Solver[™]
BULLETIN

Front Coil Spring Failure

2000-2007
Ford Focus

MOOG® Coil Spring 80170, 80172 and 81030

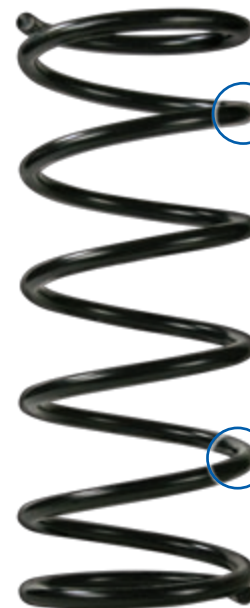
Stress and corrosion can cause front coil springs to fracture and fail, resulting in suspension noise and sagging.

MOOG offers a replacement constant rate coil spring designed to provide more strength and durability:

- Larger diameter bar and additional coils reduce stress throughout the spring to combat fatigue.
- Improved coated material resists corrosion.
